Item ID: D212-664-101

Item Name: Crosstube Fwd High

DRAWING NO. D212-664-141	TITLE XTUBE ASSY (205/212/412 HI FWD)	REV. D	DART AEROSPACE LTD ENGINEERING ORDER		D.E.O. NO. D212-664-141-D-1	SHEET NO. SHEET 1 OF 2	SCALE NTS
DRAWN	CHECKED	MFG. APPR.	APPROVED	DE APPR.			
DATE 11.04.07	DATE 11.04.11	DATE 11.04.12	DATE 11/04/12	DATE 11.04.12

PURPOSE:
ADD AN INSPECTION WINDOW TO UNDERSIDE OF CROSSTUBE.

D212-664-141/-141B
ASSEMBLY DETAIL

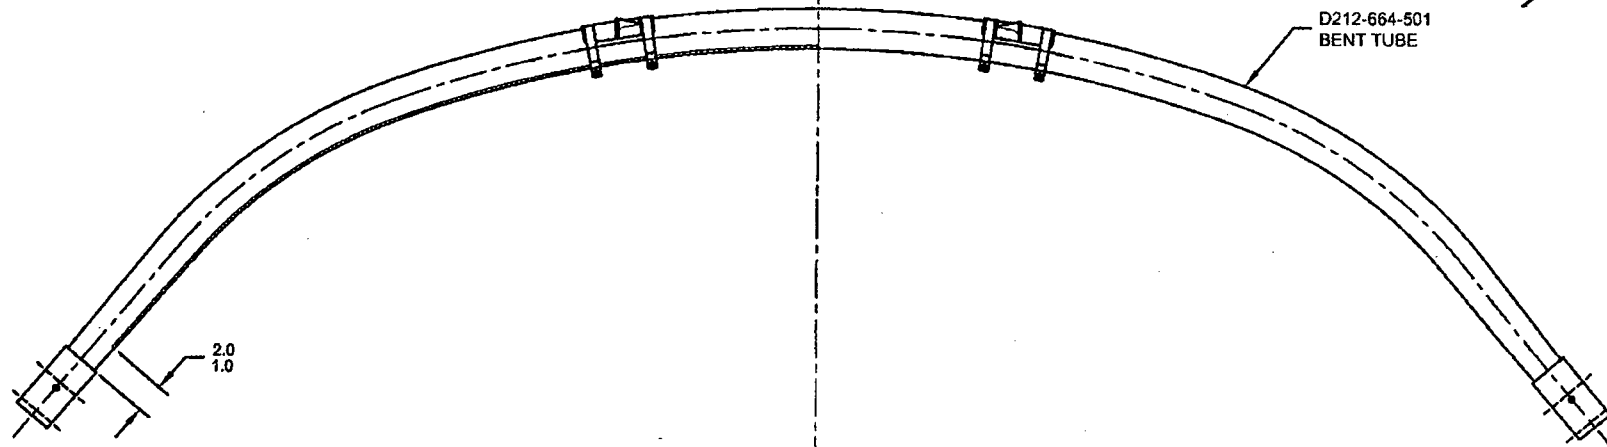
- 2) FINISH: CHEMICAL CONVERSION COAT PER DART QSI 005 4.1
PRIME INSIDE AND OUTSIDE PER DART QSI 005 4.2
MASK UNDERSIDE OF CROSSTUBE AS SHOWN (HATCHED AREA) AND
PAINT OUTSIDE PER DART QSI 005 4.2
REMOVE MASKING AND APPLY CLEAR COAT

- 2) FINISH: CHEMICAL CONVERSION COAT PER DART QSI 005 4.1
PRIME INSIDE AND OUTSIDE PER DART QSI 005 4.2
PAINT OUTSIDE PER DART QSI 005 4.2

MASK AREA PRIOR TO PAINTING,
REMOVE MASKING AFTER PAINT
AND APPLY CLEAR COAT
